PLANNING COMMITTEE
Thursday 09 July 2020

- ADDENDUM TO AGENDA -

Item 5.1 – 19 Downsview Road

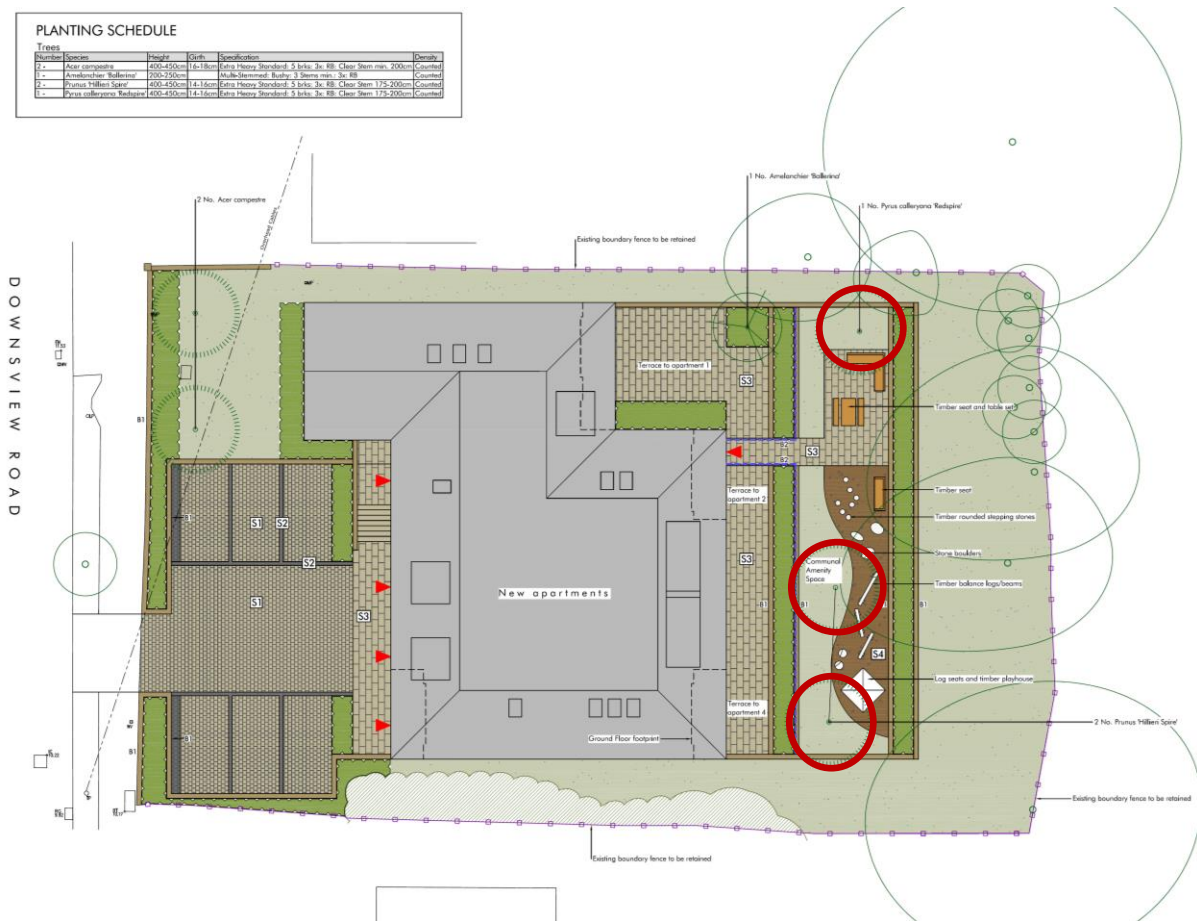
Amendments made to landscaping scheme and additional details/sectional plans of tree planting have been provided. These (primarily) constitute the planting of 3 additional trees within in consultation with the Council Tree Officer. Additional Trees are shown circled in red on the amended landscaping plan below (more details will be on committee presentation).
